Product Change Notification: PCN-23-168223

HDR ASSY, VERT., SURFACE MOUNT, SM AND THRU-HOLE HOLDDOWN, TIN AND GOLD, DUAL ROW, MICRO MATE-N-LOK.

Description of Changes

We are doing improvements in the customer drawings in order to make them standardized, clearer and with more and better information. (Marked Copies available)

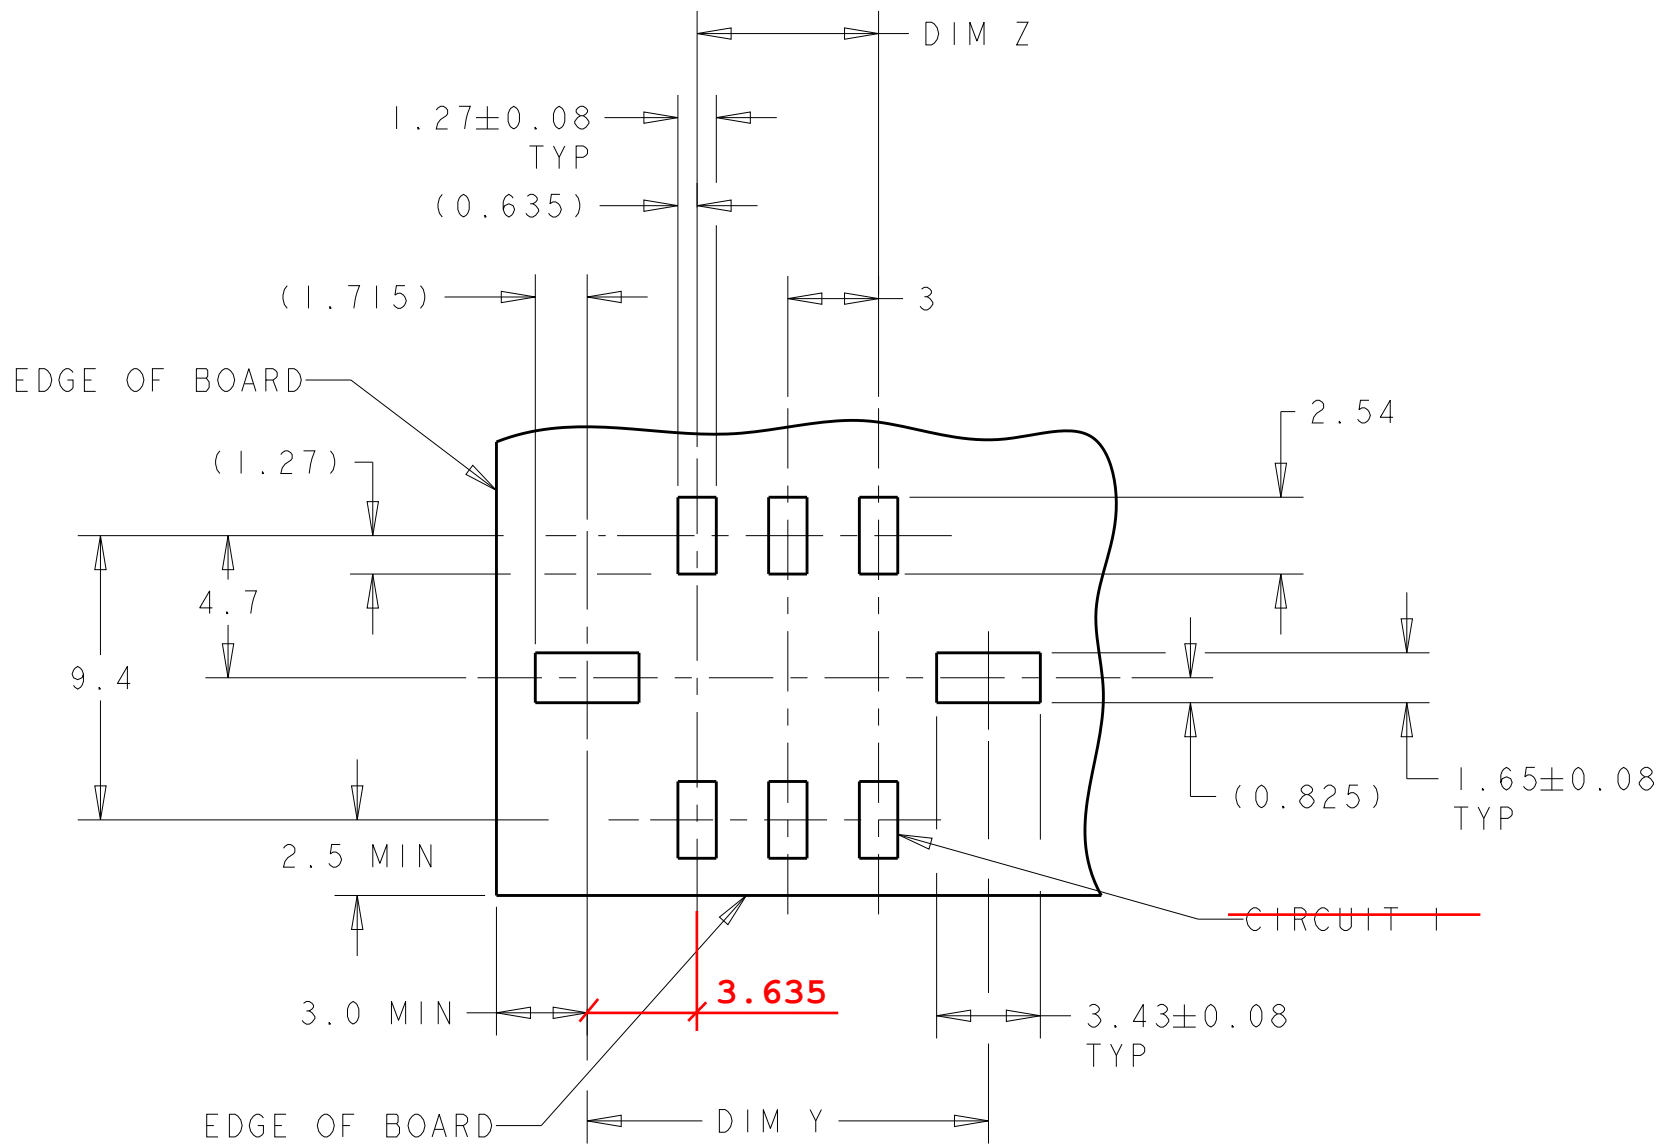
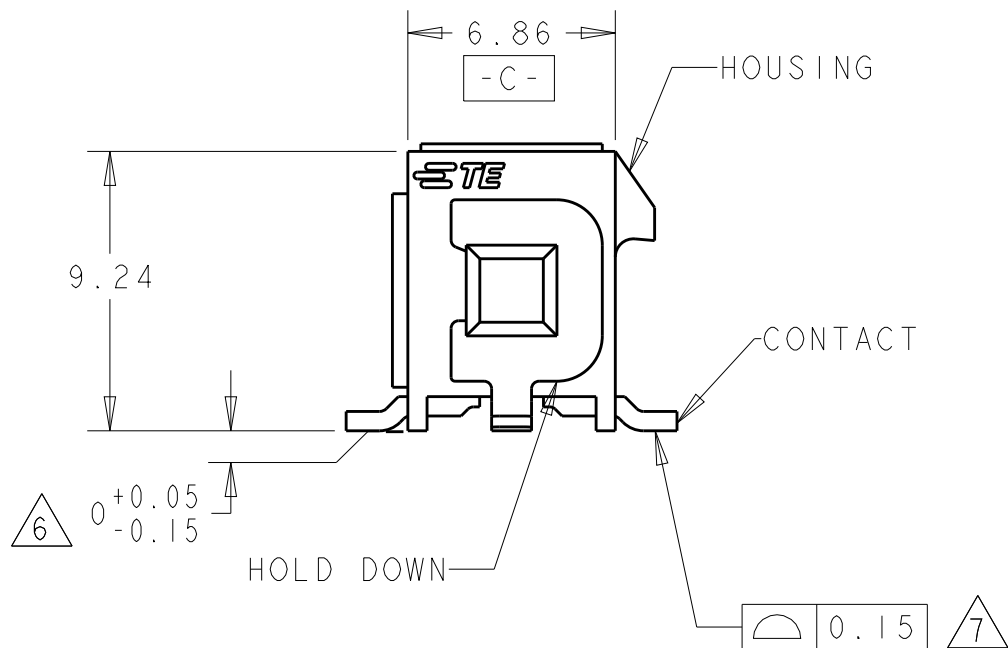
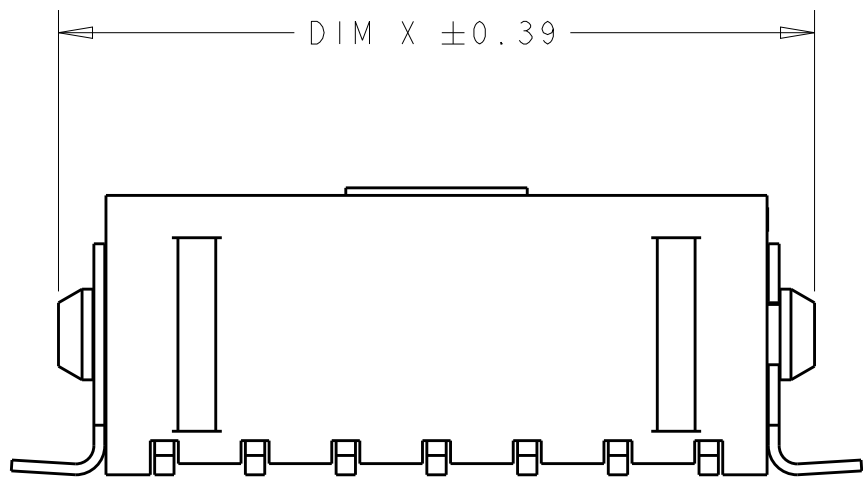
ADDED IN A SHEET 2 ALL KEYING BY POSITION SIZE
ACCORDING TO FOUND IN THE COMPONENT HOUSING DRAWING.

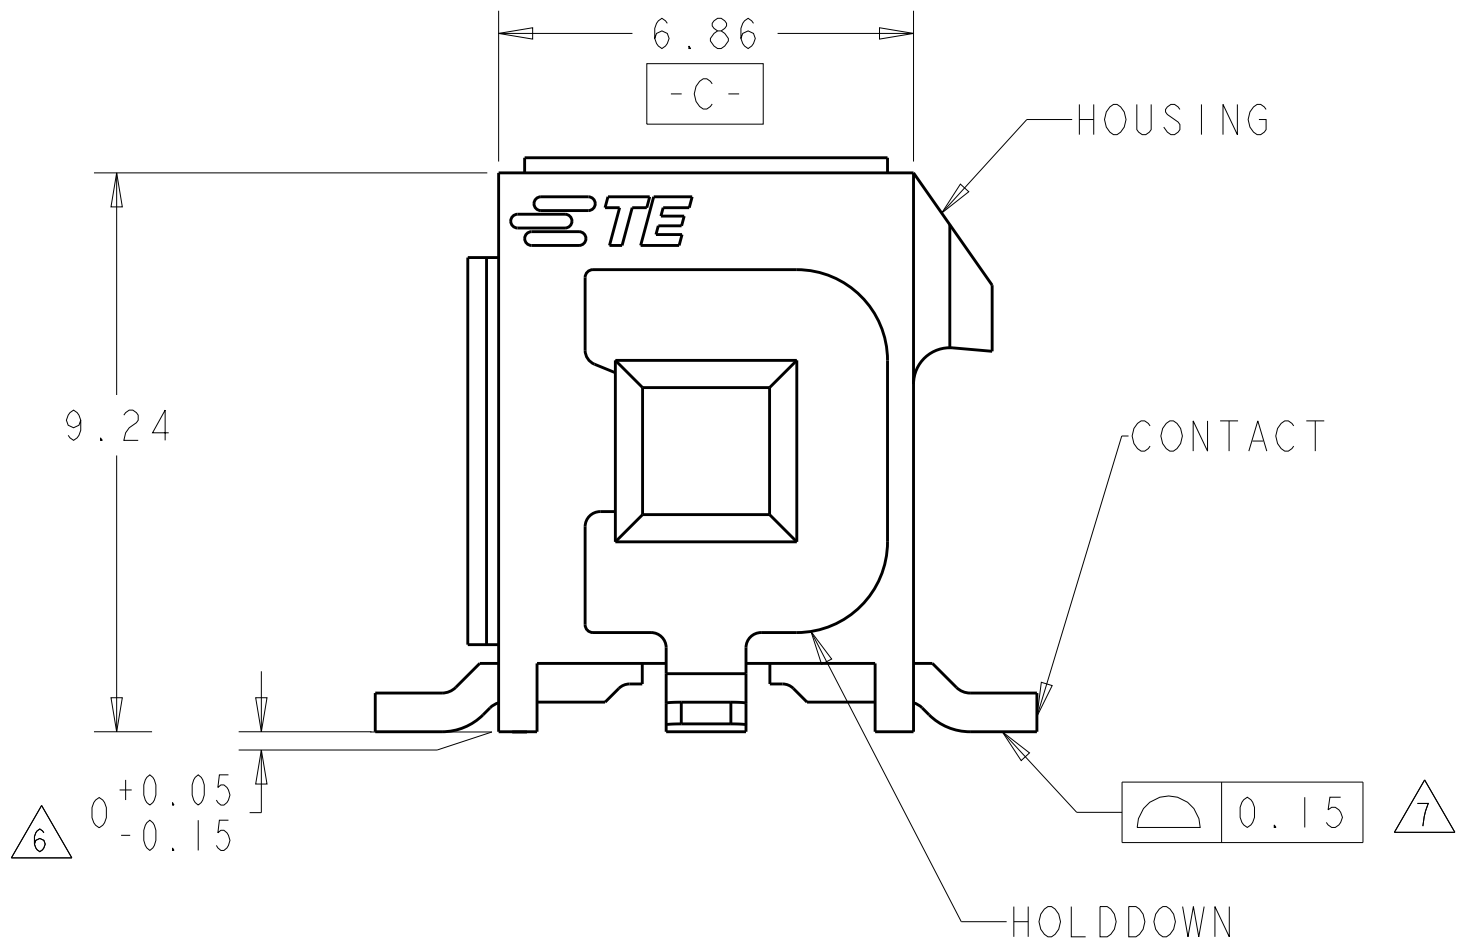
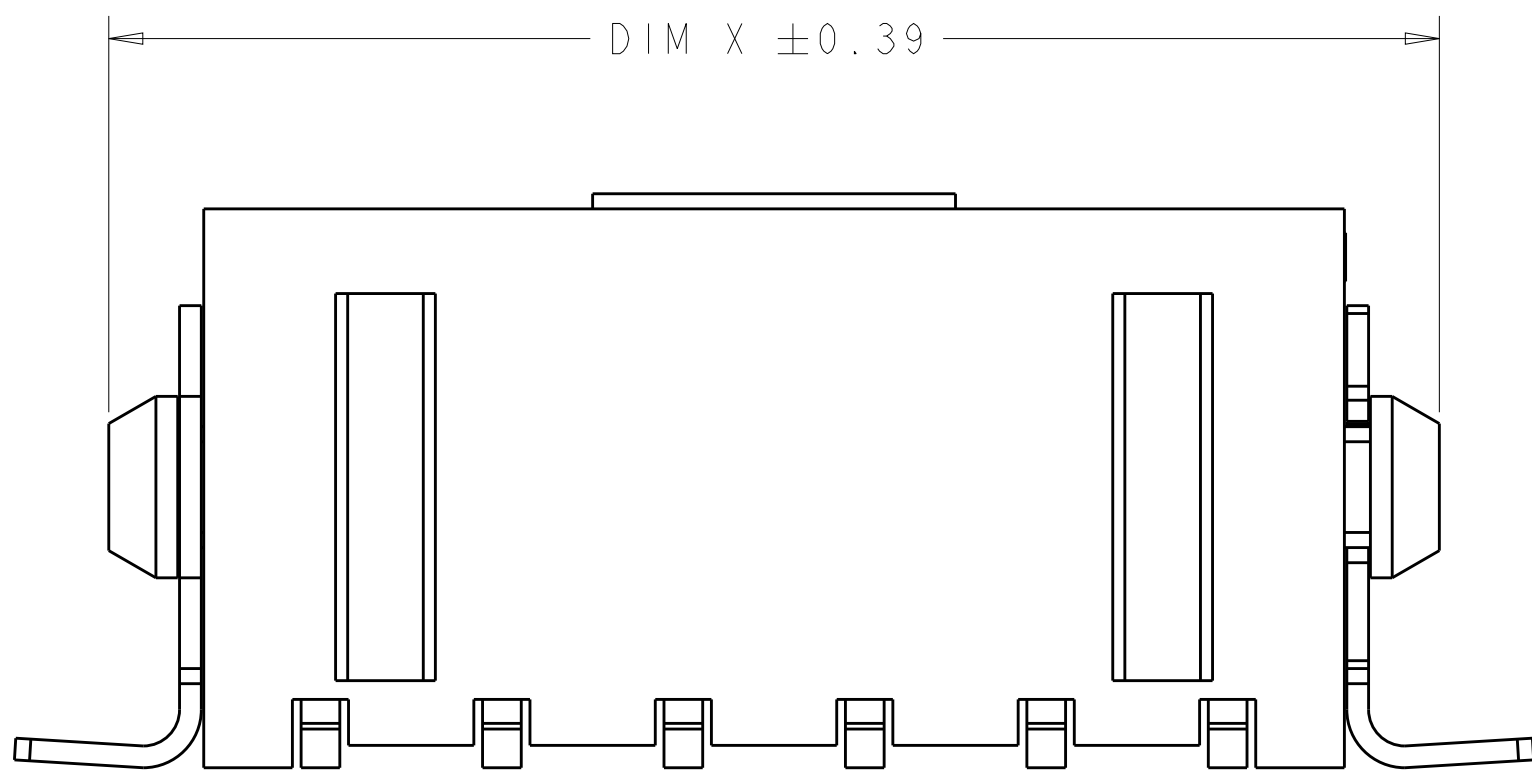
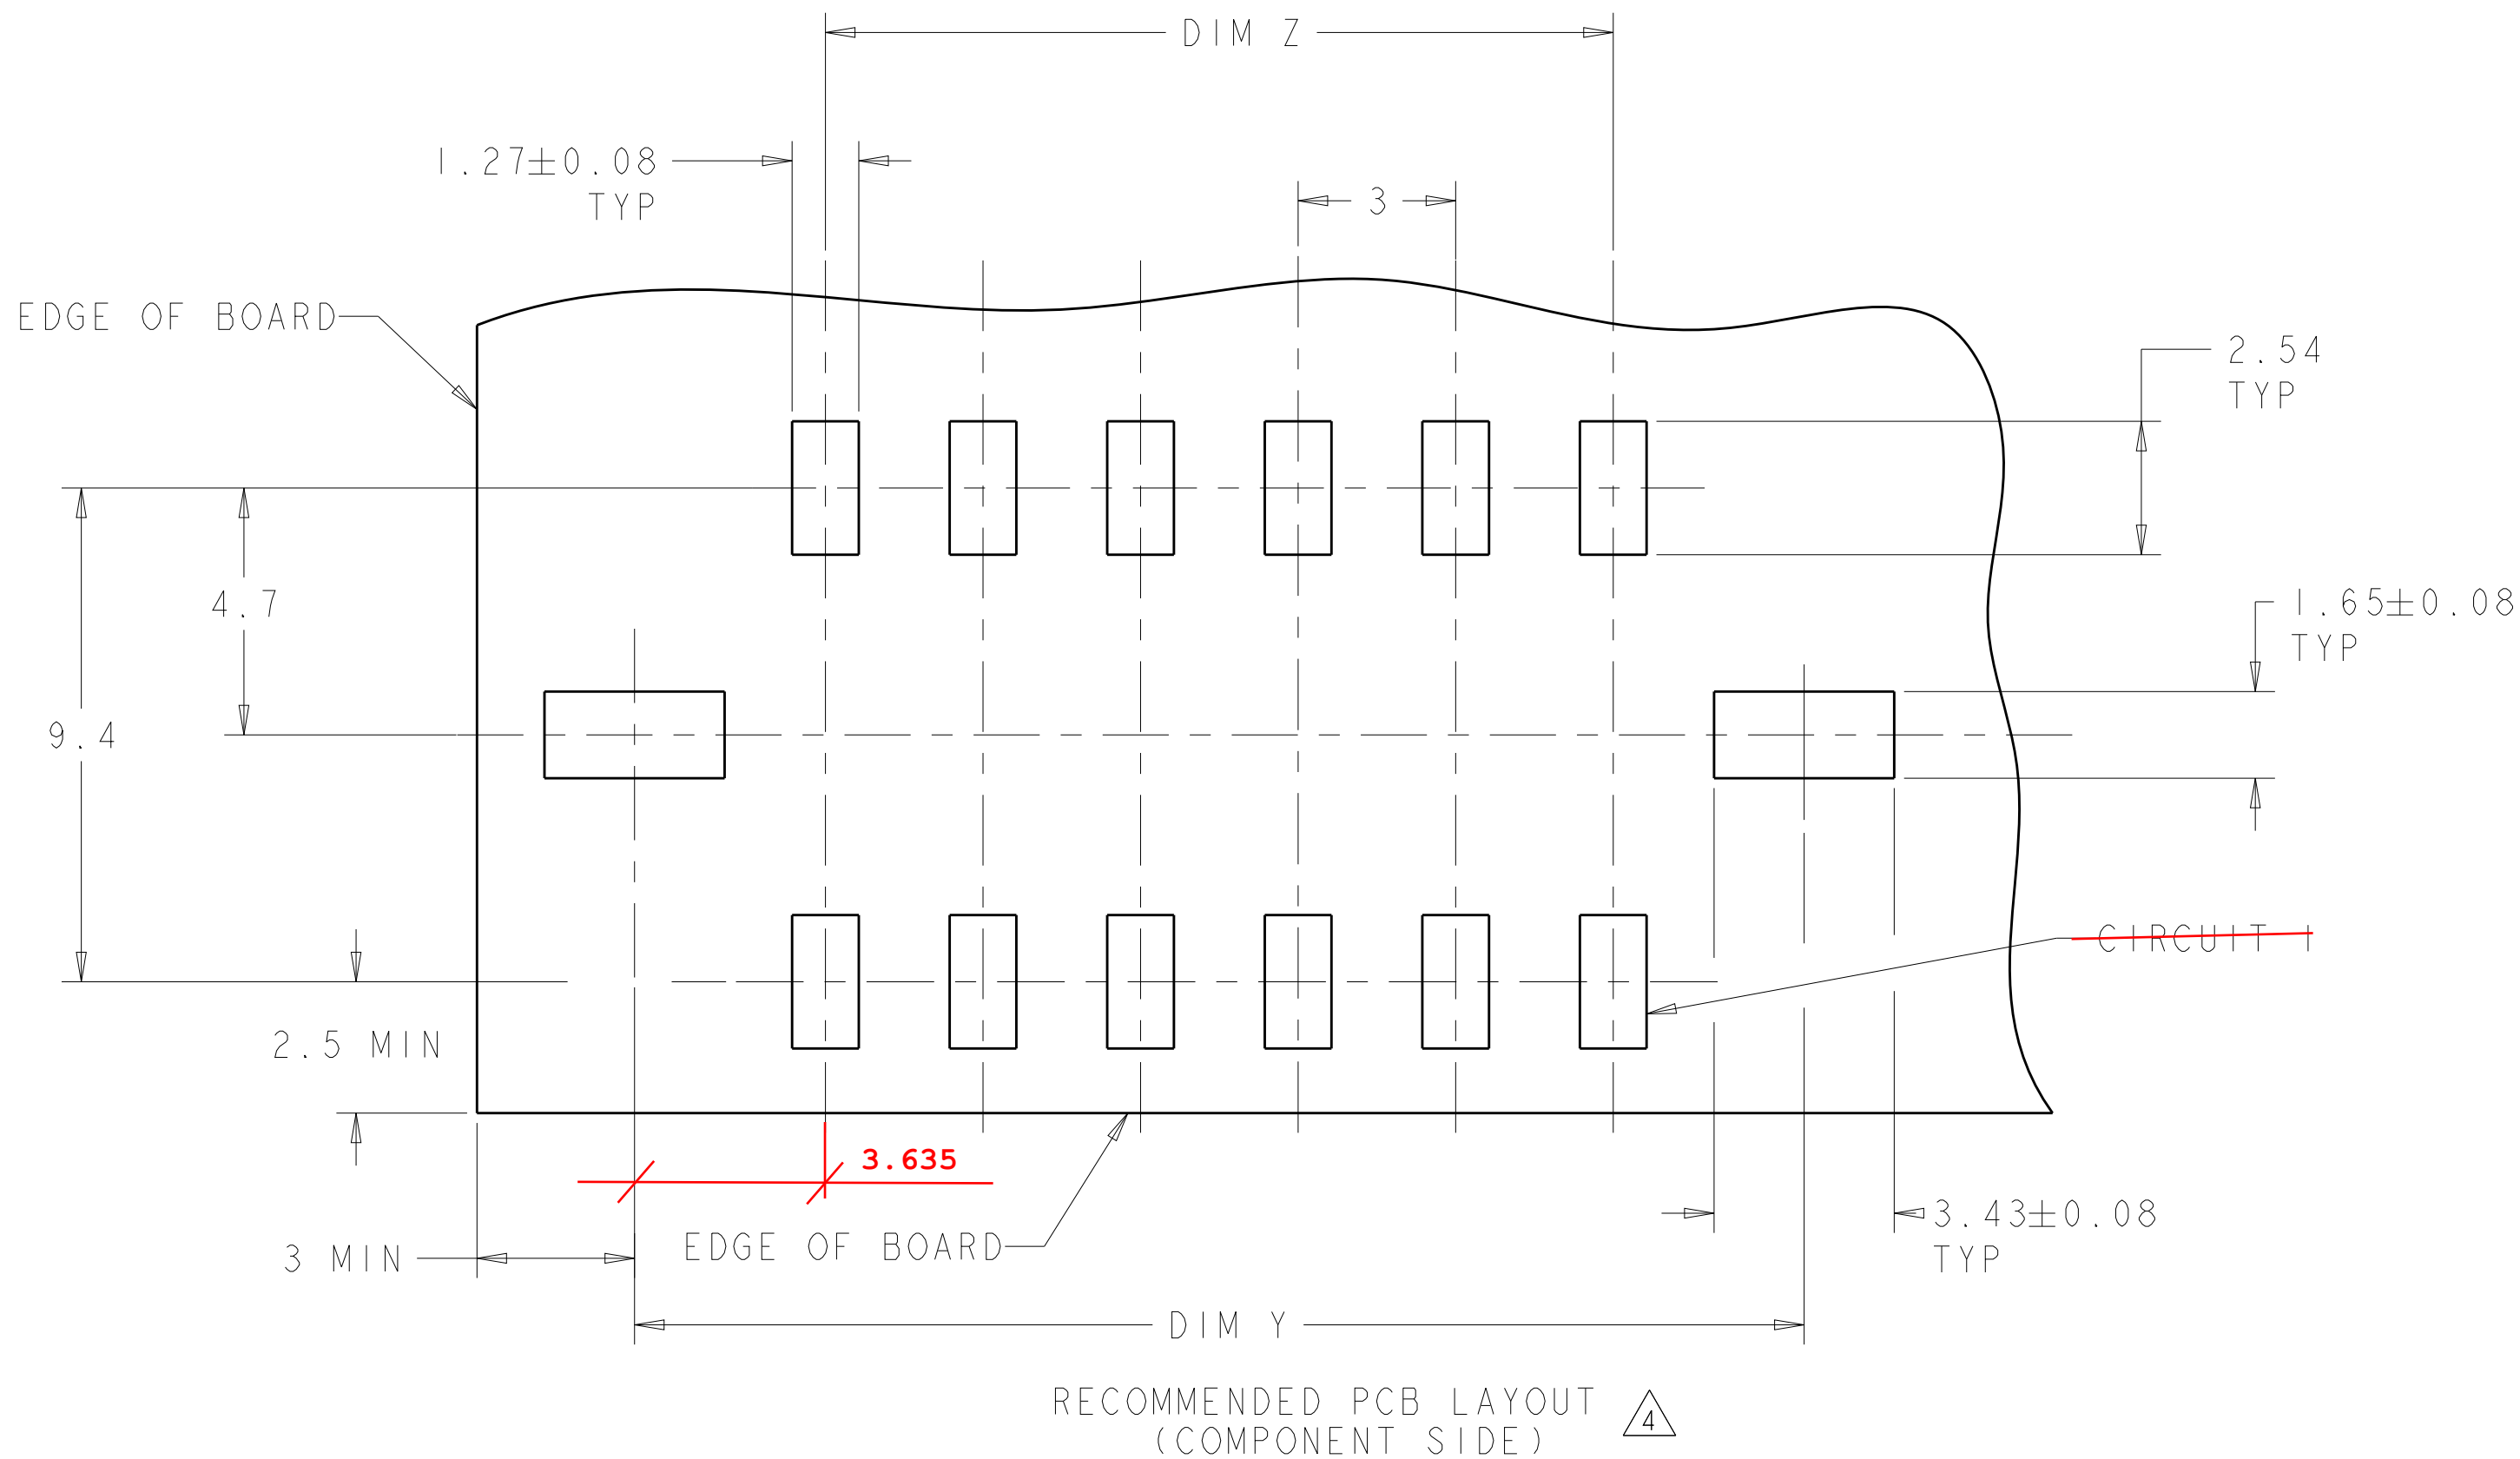
ADDED IN A SHEET 2 ALL KEYING BY POSITION SIZE
ACCORDING TO FOUND IN THE COMPONENT HOUSING DRAWING.

- 1 MATERIAL;
CONTACTS - BRASS.
HOUSING - UL 94V-0 RATED HIGH TEMP NYLON, COLOR; BLACK.
HOLDDOWNS - PHOSPHOR BRONZE.
- 2 PLATING;
CONTACTS - 0.76µm MINIMUM GOLD ~~OVER 2.54µm MINIMUM NICKEL~~ ON MATING AREA. 2.54µm MATTE TIN MINIMUM ~~OVER 2.54µm NICKEL MINIMUM~~ ON SOLDER TAILS.
HOLDDOWNS - ~~2.54µm MATTE TIN.~~
2.54µm MINIMUM MATTE TIN ONVER 1.27µm MINIMUM NICKEL.
- 4 RECOMMENDED PC BOARD THICKNESS OF 1.57.
- 5 KAPTON VACUUM PICK UP BUTTON.
- 6 DIMENSION APPLIES TO SOLDERTAIL SURFACES AND STANDOFF SURFACES.
- 7 ALL SOLDERTAILS AND HOLDDOWNS.
- 8 SPECIAL PACKAGING FOR IEC 286-3 REQUIREMENT. PARTS ORIENTED 180° DIFFERENT IN TAPE THAN STANDARD PART NUMBER 794638.
